ADDENDUM NO. 2

PROJECT: **Frog Eye Road Bridge Replacement**
County Contract No. BR-FE-225-14

FROG EYE ROAD
BRIDGE REPLACEMENT

COUNTY CONTRACT NO. BR-FE-225-14

SHEET NO.
12R

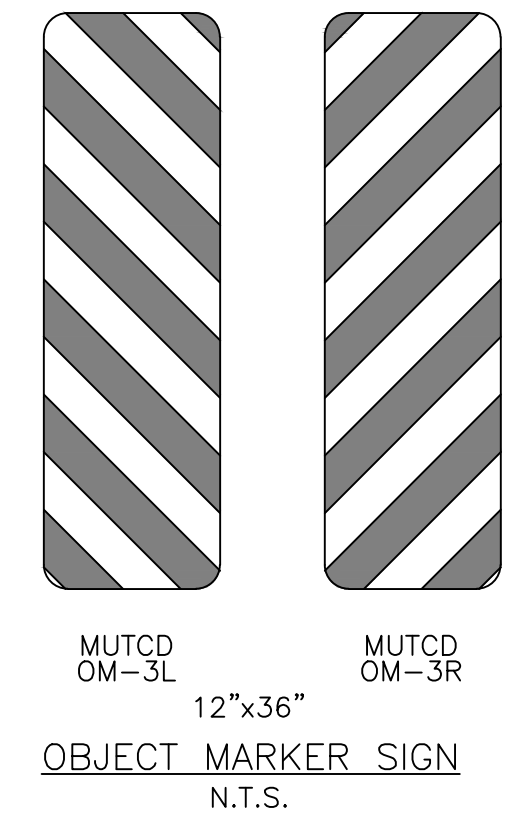
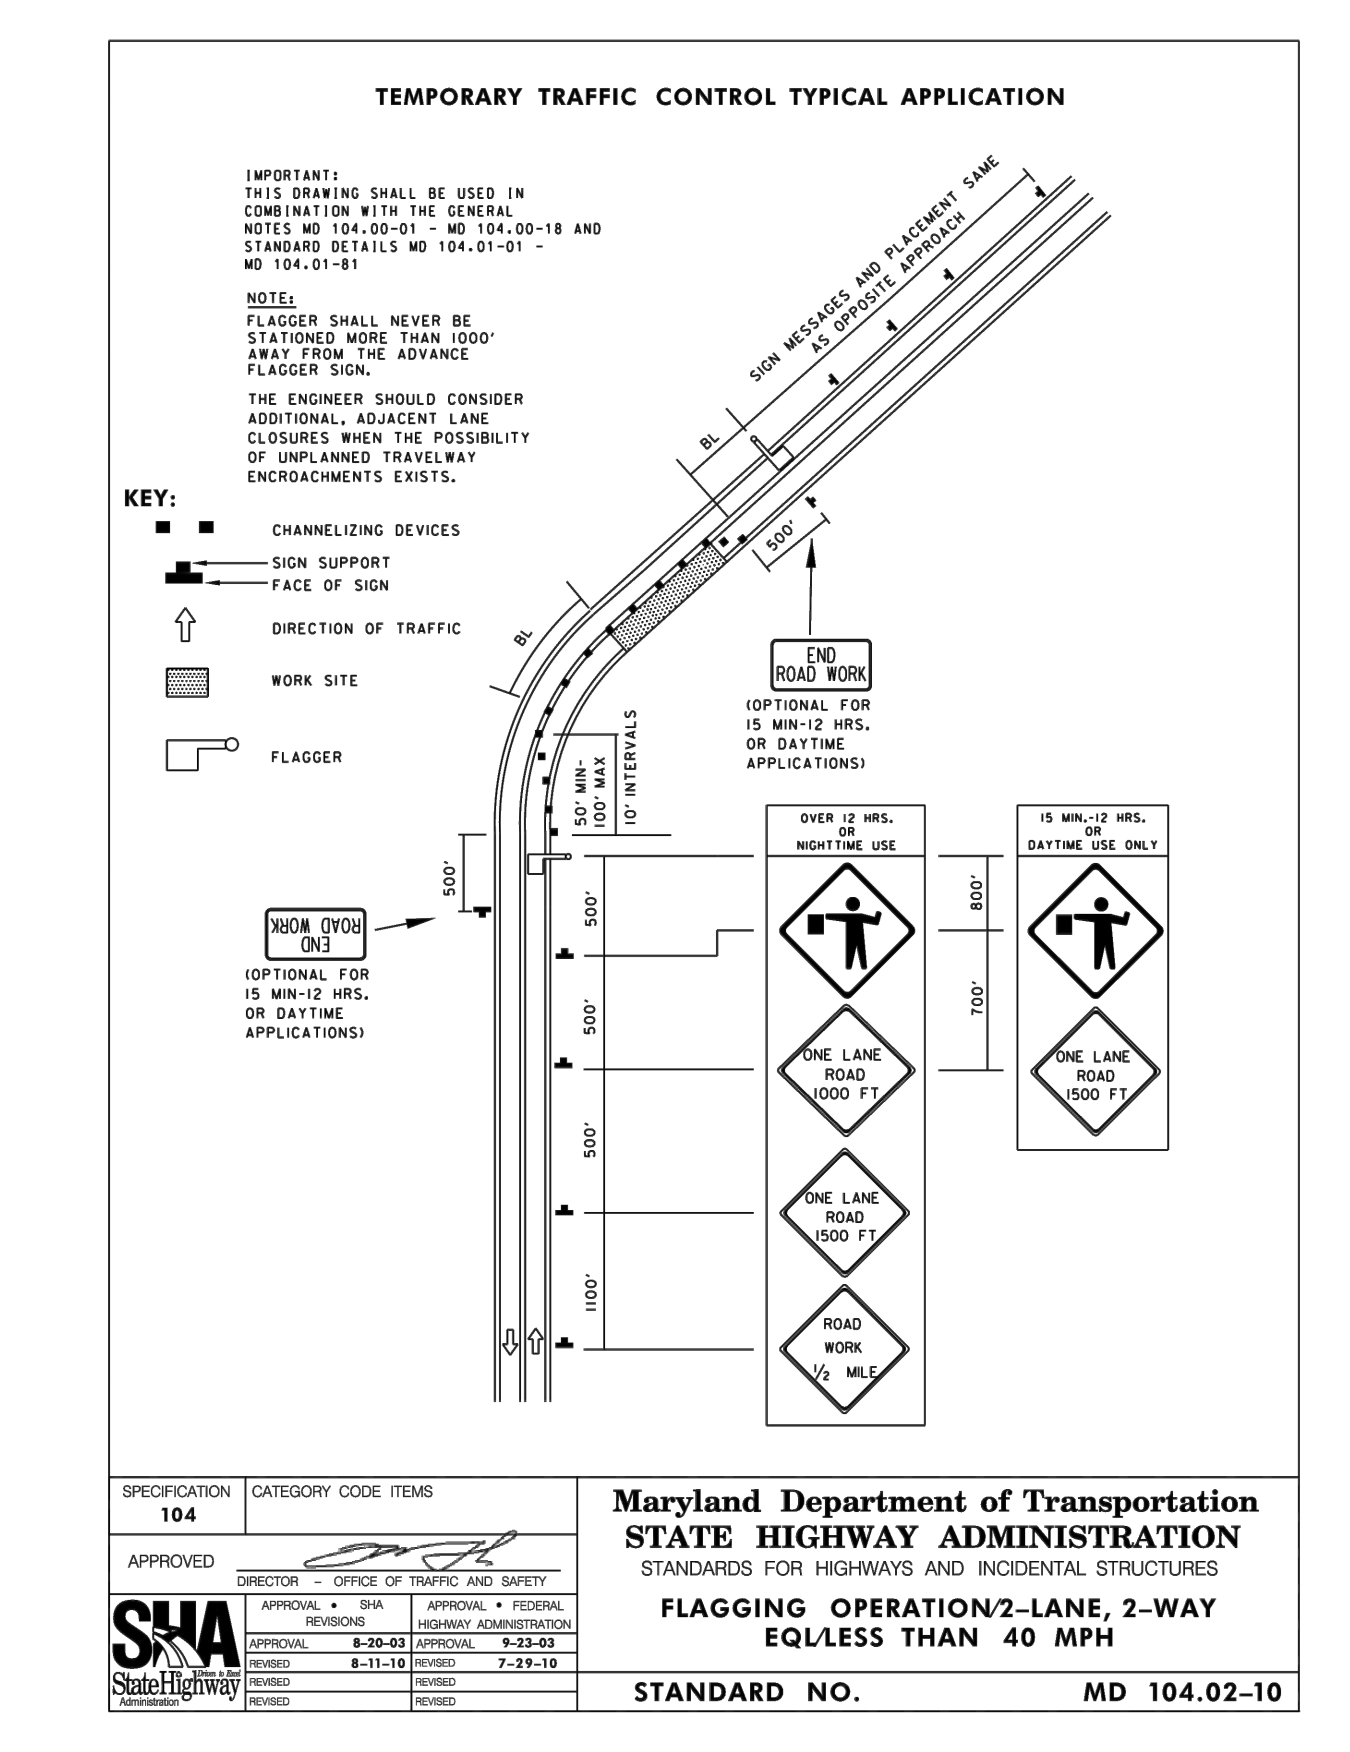
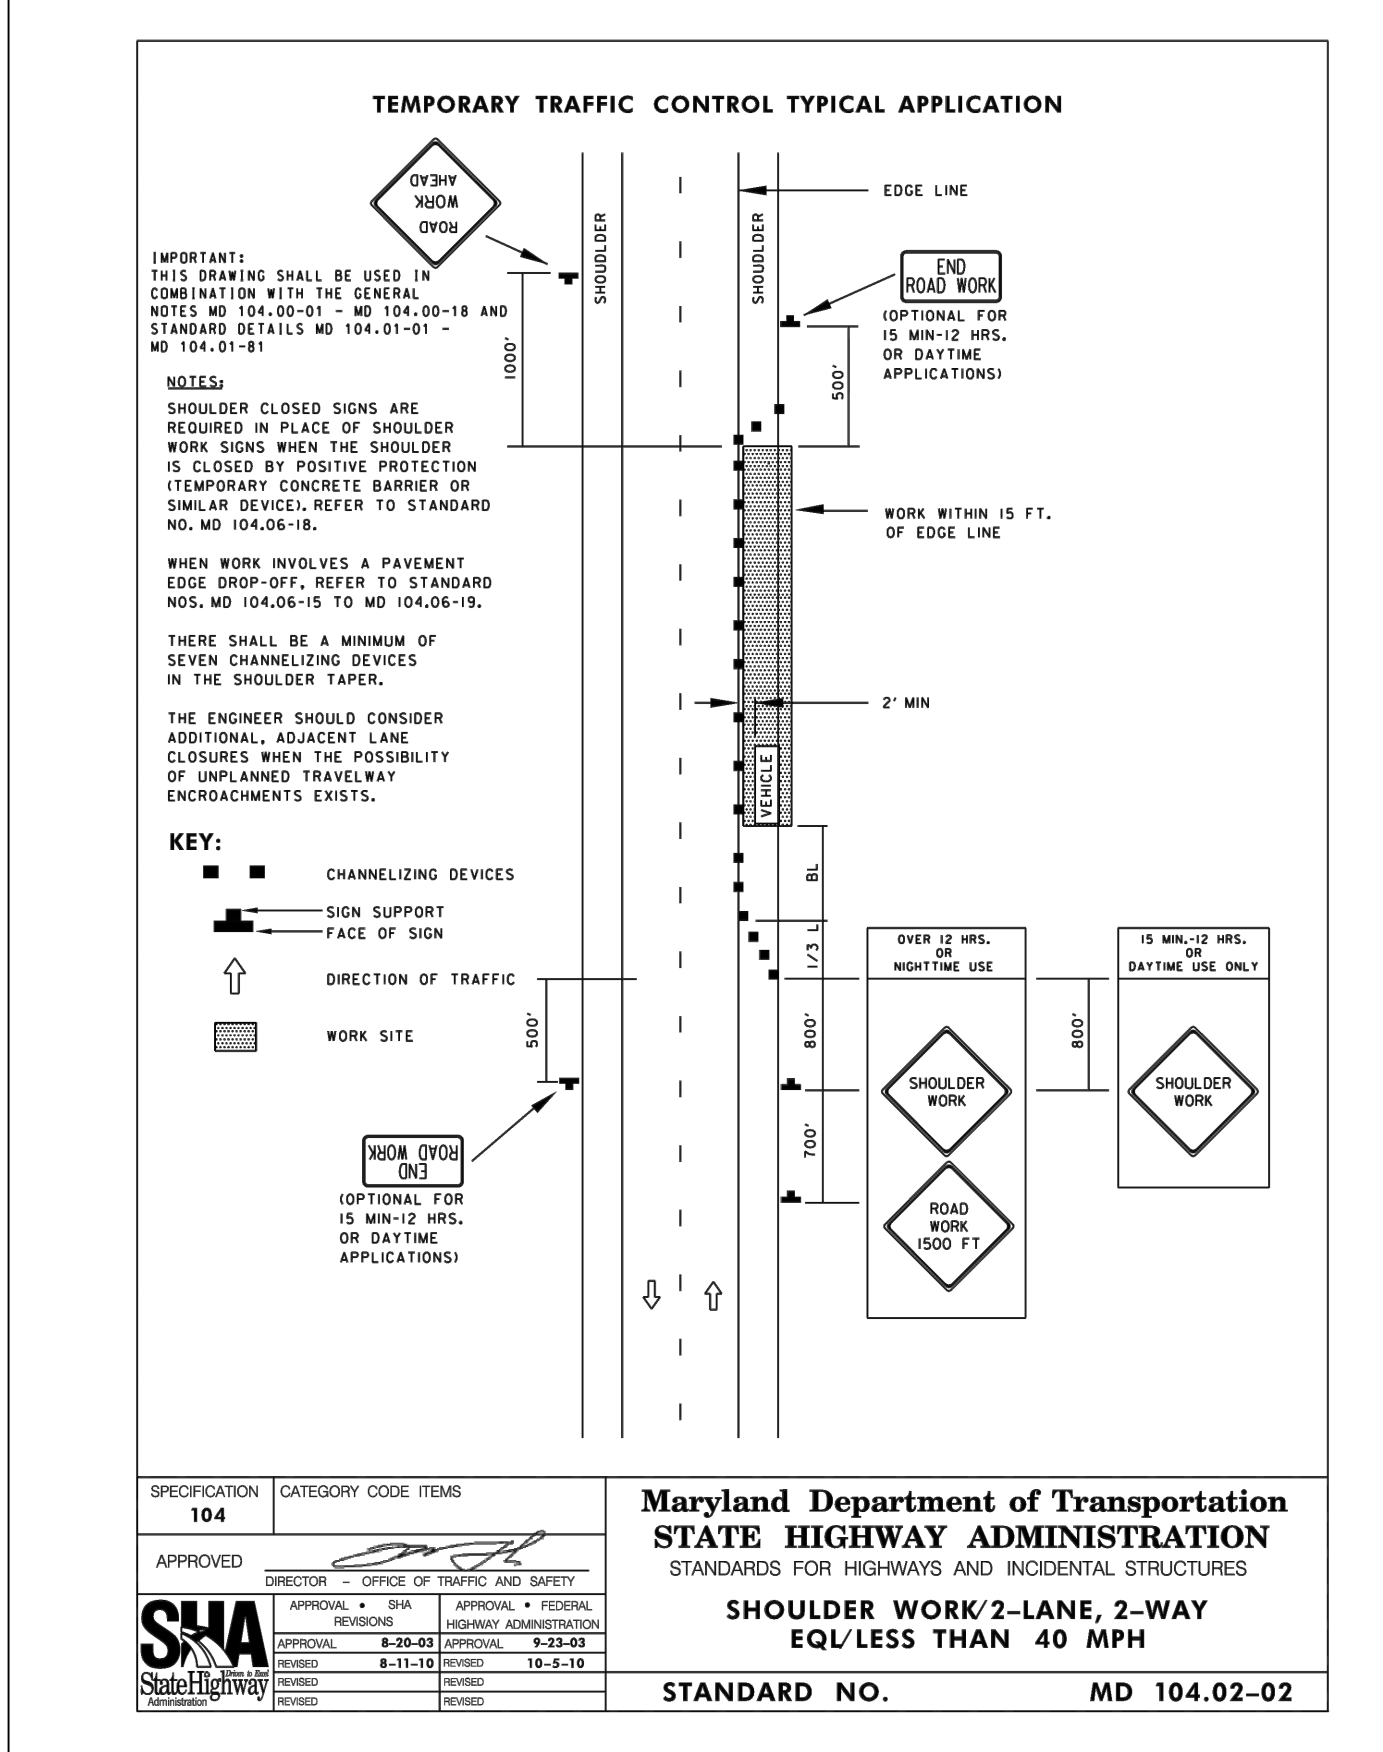
Q11: Is any temporary barrier required after traffic is shifted to the new structure and the existing is being demolished (prior to the installation of the final proposed w-beam)?

R11: Yes, Item 105 – Temporary Concrete Traffic Barrier (TCTB) for MOT shall be used. See added note 10 on revised plan sheet 12R, attached. All temporary concrete traffic barriers for MOT must include reflective barrier markers. The quantity for this item has been increased from 48 LF to 168 LF.

10. ADDITIONAL TEMP CONCRETE TRAFFIC BARRIER SHALL BE USED ON BOTH SIDES OF THE NEW STRUCTURE WHEN TRAFFIC IS DIRECTED ACROSS AND PRIOR TO PERMANENT TRAFFIC BARRIER INSTALLATION.
